Planning Commission Meeting Agenda,

209 PLAYHOUSE STREET VARIANCE APPLICATION

To: Planning Commission
From: Cindy Nash, AICP, EDFP
Date: August 31, 2023
Subject: Variance – 209 Playhouse

**CITY OF COLOGNE
PLANNING COMMISSION
RESOLUTION NO. 23-01
RESOLUTION DENYING VARIANCE FOR 209 PLAYHOUSE STREET EAST**

CERTIFICATE OF SURVEY

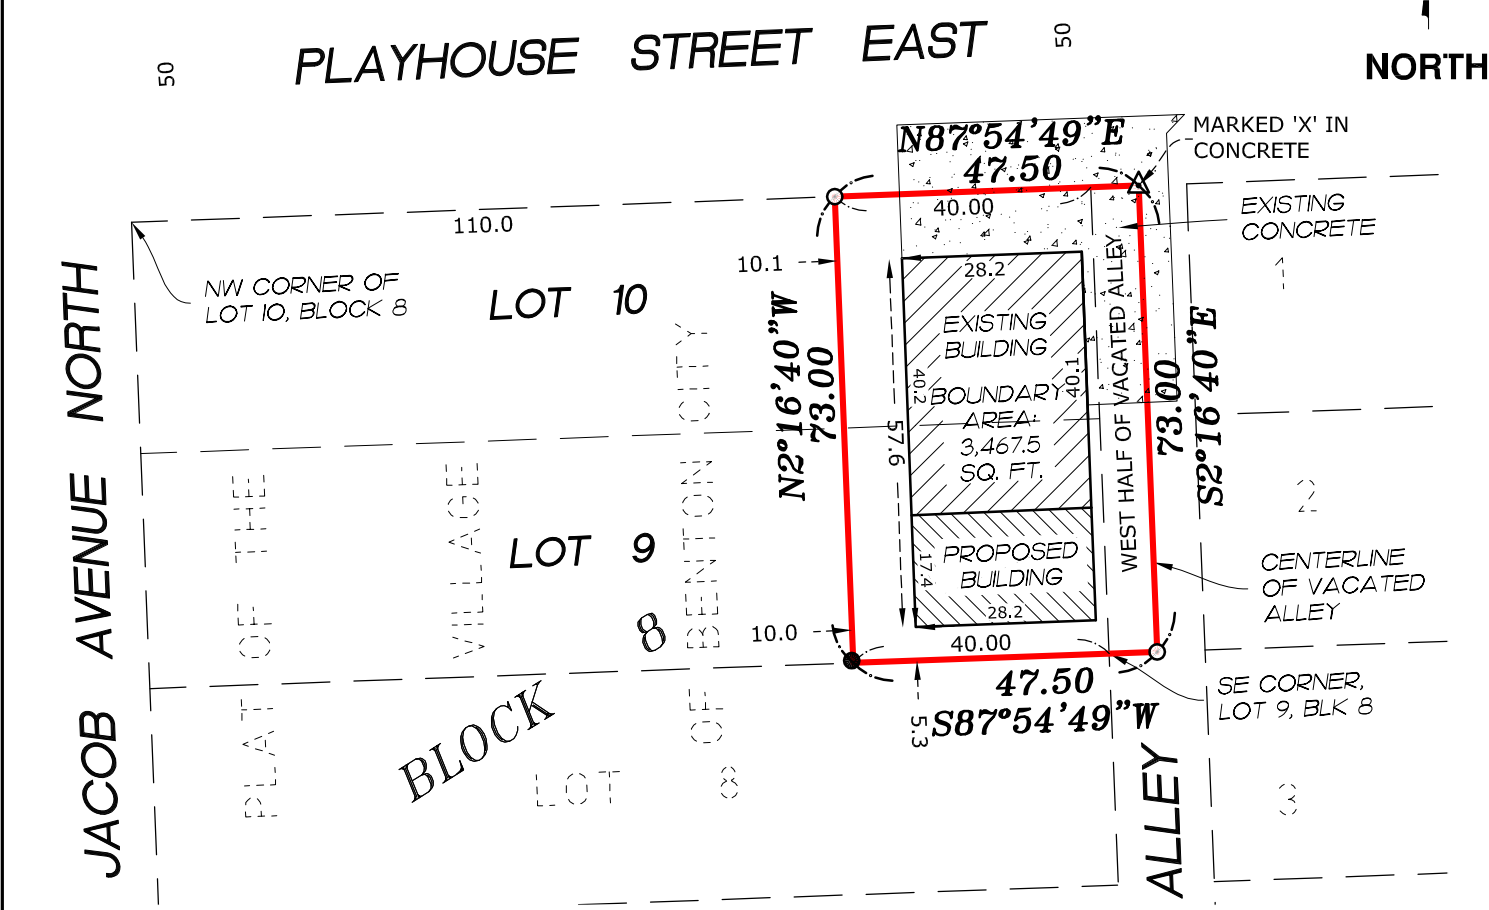
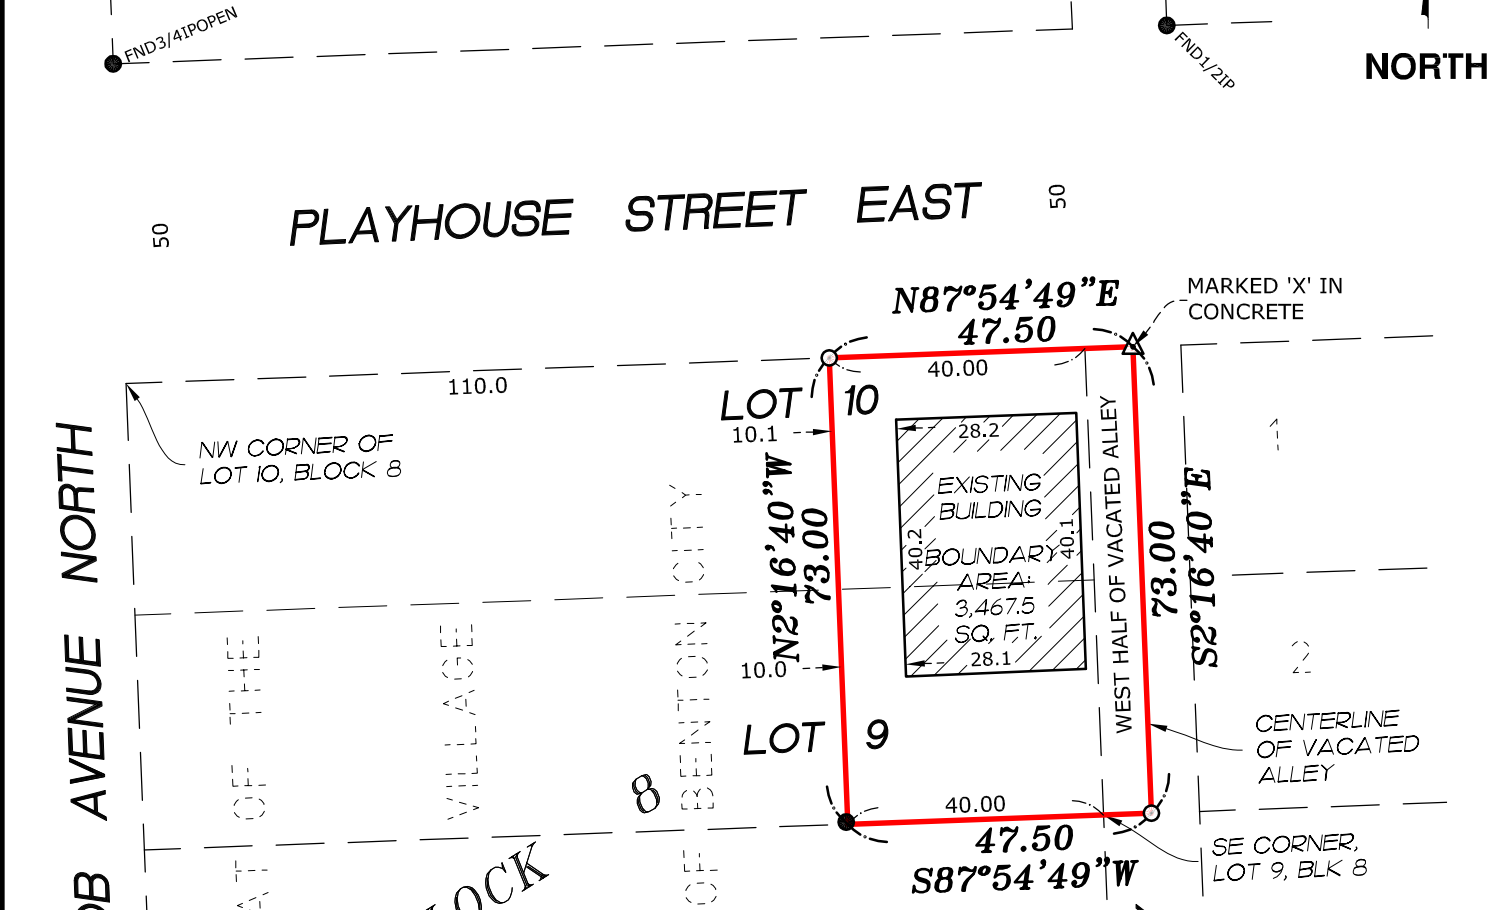
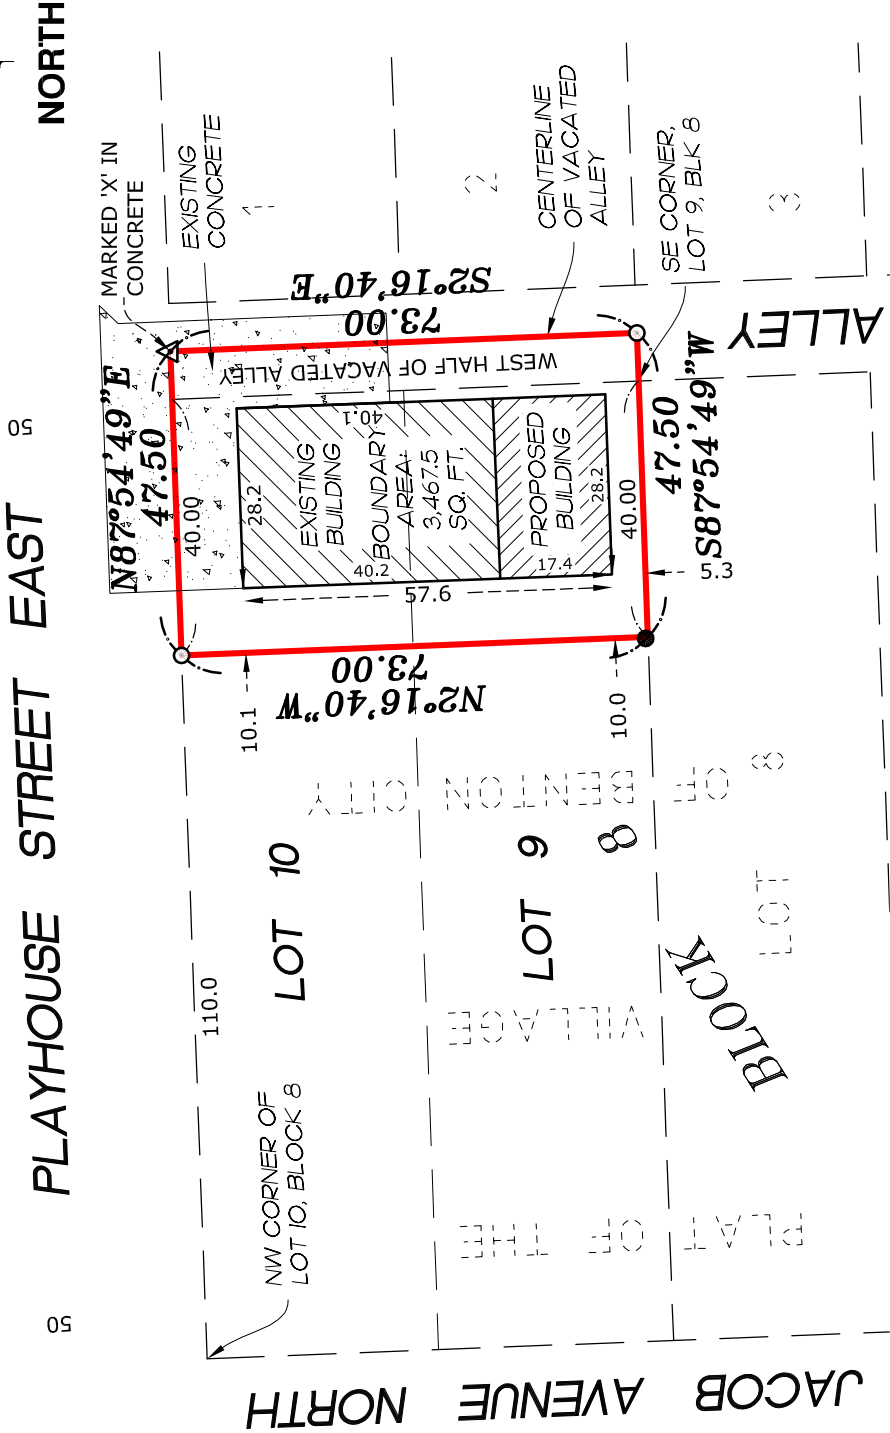
The applicant is requesting approval for a site plan with an impervious surface coverage of 64% of the parcel in the shoreland overlay area, when the maximum permitted is 25%. The survey depicts this as an increase from the “existing” condition of impervious surface of 50%.

WHEREAS, the Applicant submitted a revised application and plan set on August 22, 2023 (“Revised Application”) that reduces the size of the proposed addition to an additional 493.43 square feet and 64% impervious surface coverage and also provided the following list of activities for the building:

BE IT FURTHER RESOLVED that the Planning Commission hereby denies the application to issue a variance to permit impervious surface coverage of 64% to allow an expansion of a non-conforming use in the C-2 Zoning District.
